ANN ARBOR HISTORIC DISTRICT COMMISSION

Staff Report

ADDRESS: 537 Detroit Street, Application Number HDC17-148

APPLICATION: The applicant seeks HDC approval to remove a non-contributing 12'x17' garage and replace it with a 24'x 32' gravel parking area.

Drawing showing existing and proposed parking area on a Survey to Scale.

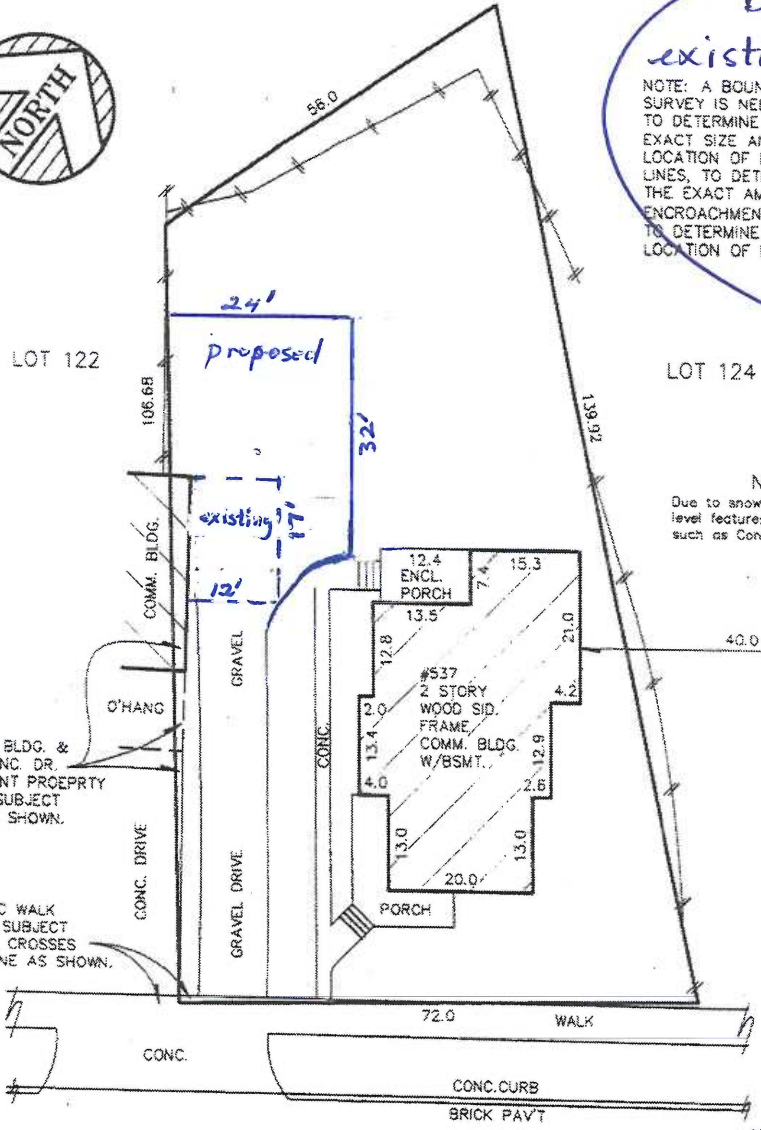
1. This property was extensively restored by a previous owner in 2008-2010, when it was an owner-occupied duplex. The property is now a two-unit rental. The site is immediately north of Treasure Mart, and it should be noted that the side wing of that business encroaches across this property's south lot line.
2. The current garage is in extremely poor condition and was previously determined by the HDC to be noncontributing. Though an application to demolish the garage was given a certificate of appropriateness in 2008, the work was never done. This portion of the application is appropriate.
3. The footprint of the existing garage is 12' x 17'. The applicant proposes to enlarge the parking area to 24' x 32', with a retaining wall up to 32" high around the west and north

sides. The lot slopes from the street toward the backyard. The retaining wall would be built of 6"x6" treated lumber. The parking area would legally provide two parking spaces, with space for several more stacked vehicles. The 24' width is appropriate for two cars since the parking area abuts a fence on the south and has a retaining wall on the north, both of which necessitate more room for door swing and safe entry/exit.

4. At the Review Committee site visit in April, HDC members and staff observed a large amount of gravel dumped along the single-car-width driveway to facilitate parking on the lawn next to the driveway. The double-width driveway is inconsistent with the historic landscape pattern of the site, destroys historic relationships, and is visually incompatible with the site and the neighborhood. This work was done without permits and needs to be addressed in the approval motion. An alternate motion for enforcement is suggested should the HDC not approve the request to build a new parking area.

5. Staff's suggested motion conditions the approval on the width of the driveway not exceeding 10' from the curb and structure to the south, which matches the current width, and removal of gravel from the lawn and restoration of grass in that area. Should parking continue anywhere on the lot other than on the driveway or parking area specified in this application, vehicles will be ticketed and staff will begin enforcement proceedings.

- (1) The driveway does not exceed 10 feet in width from the curb to the south or the structure on the lot to the south, and the gravel will be removed from the lawn along the driveway, and grass restored between the driveway and concrete walk; and
- (2) Either the driveway and parking area must be constructed as specified in the application and the lawn restored to its former condition within 60 days, or the lawn must be restored to its former condition, prior to the installation of gravel, within 60 days.
